STAFF RECOMMENDATION

1102 Bate Avenue

October 16, 2019

Application: New Construction—Infill

$\frac{1}{3}$ **FRONT - 1102 BATE**
1/8" = 1'-0"

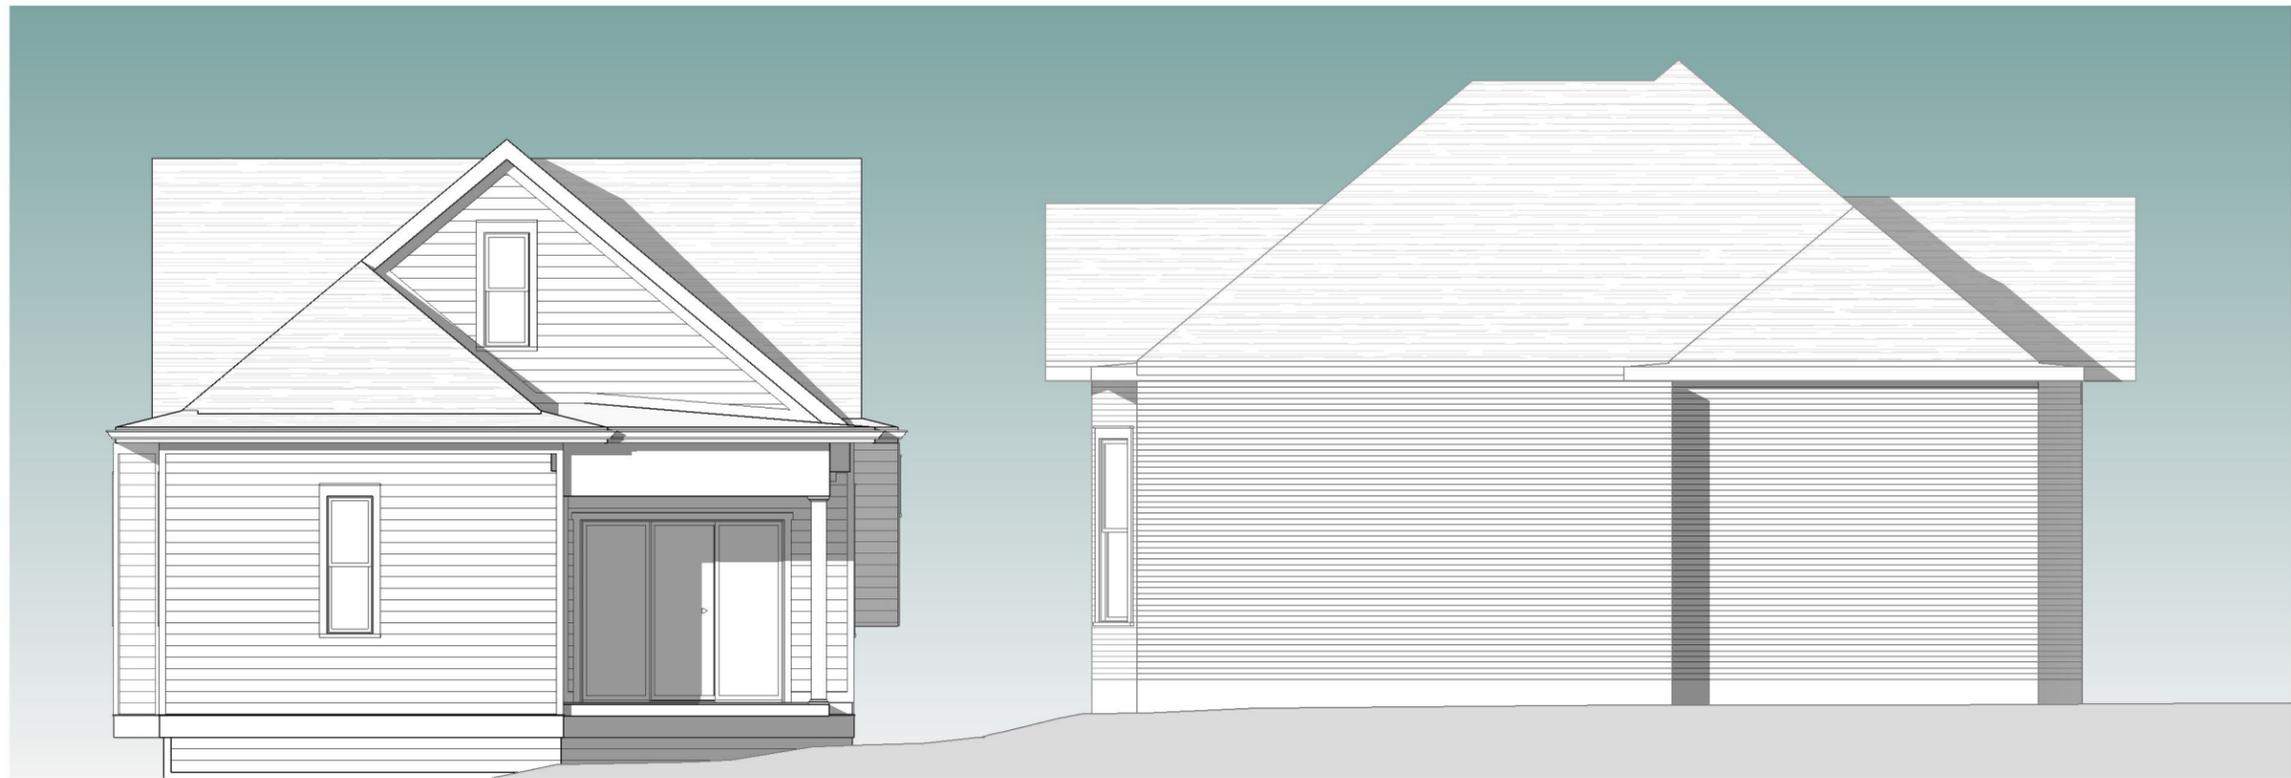
Height & Scale: The applicant has designed the house so that its height, scale, and form are compatible with the historic house next door at 1104 Bate Avenue. The house will be one-and-a-half stories with a maximum height of approximately thirty-two feet (32') from grade at the front. By comparison, the historic house at 1104 Bate Avenue is thirty-four feet (34') tall from grade. Staff finds the overall height and scale to be appropriate.

The infill has a tall foundation at the front. The lot has a significant cross slope to it, and the house next door at 1104 Bate Avenue also has a tall foundation at the front, which decreases in height towards the back of the house (Figures 4 & 5). The proposed infill's foundation at the front will be lower than the foundation height of the house next door at 1104 Bate by approximately one foot (1'). Staff finds the height of the foundation, as drawn to be appropriate because it is similar to the foundation and finished floor heights of the house next door. However, staff recommends approval of the foundation and finished floor height during construction to ensure that the foundation height is appropriate.

Roof form: The proposed infill’s primary roof form is a 10/12 hip. The roof includes 10/12 gables on the side facades, 1/12 hipped porch roofs, and a 3/12 hip detail along the side facades. Staff finds that the proposed roof form is found within the historic context and is appropriate for the site.

1. The foundation and finished floor height be consistent with the finished floor heights of the adjacent historic houses, to be verified by MHZC staff in the field;
2. Staff approve the final details, dimensions and materials of windows and doors prior to purchase and installation;
3. A walkway be added from the front porch to the street, with Staff approving the materials for walkway and stair;
4. Staff approve the roof color and masonry color, dimensions and texture; and
5. The HVAC be located behind the house or on either side, beyond the mid-point of the house.

$\frac{1}{4}$ **SIDE A**
 $\frac{1}{8}'' = 1'-0''$

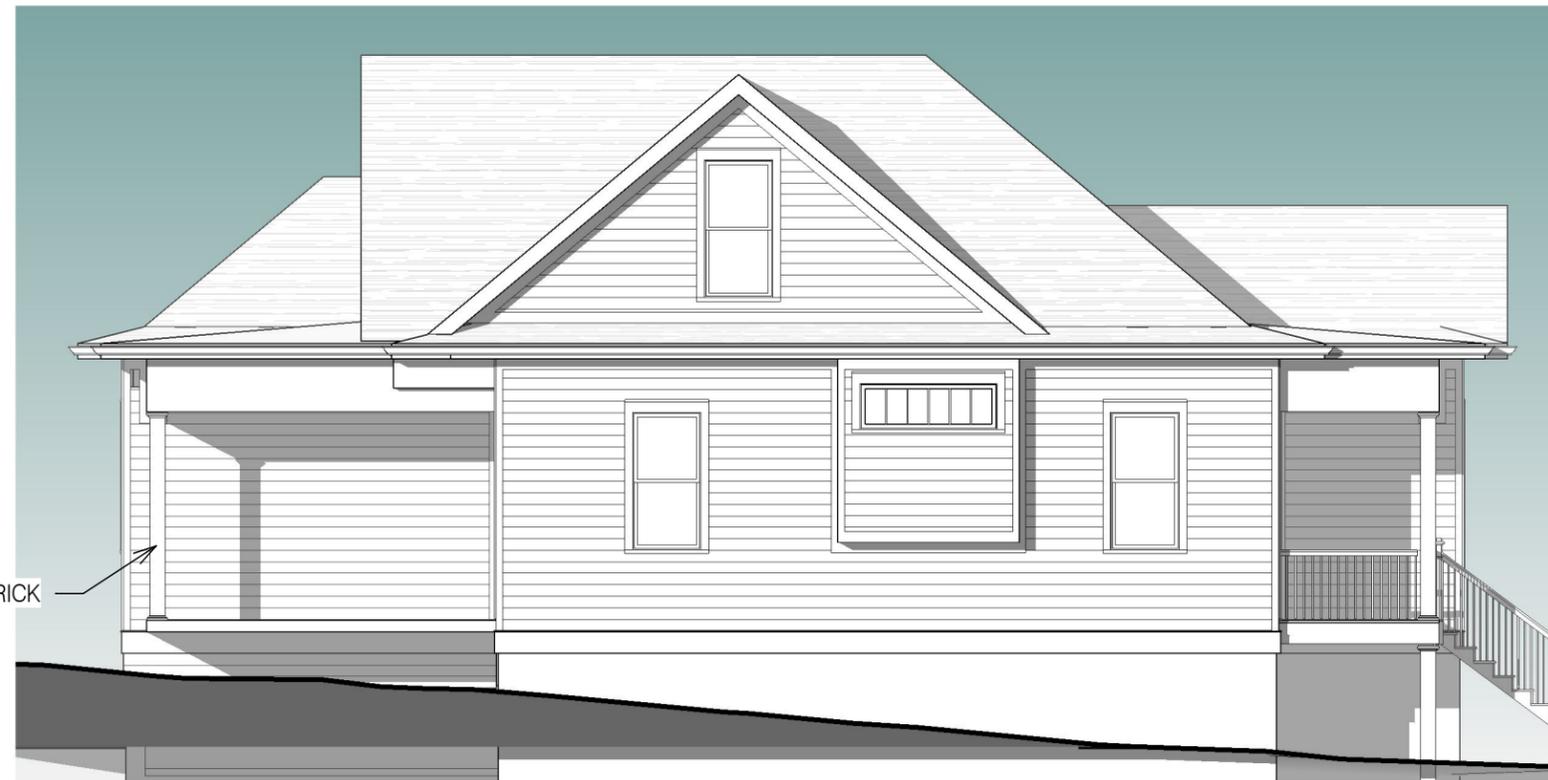
Proportion and Rhythm of Openings: The windows on the proposed addition are all generally twice as tall as they are wide, thereby meeting the historic proportions of openings. There are no large expanses of wall space without a window or door opening.

Appurtenances & Utilities: No changes to the site’s appurtenances were indicated on the drawings. The location of the HVAC and other utilities was also not noted. Staff recommends that the HVAC be located on the rear façade, or on a side façade beyond the midpoint of the house.
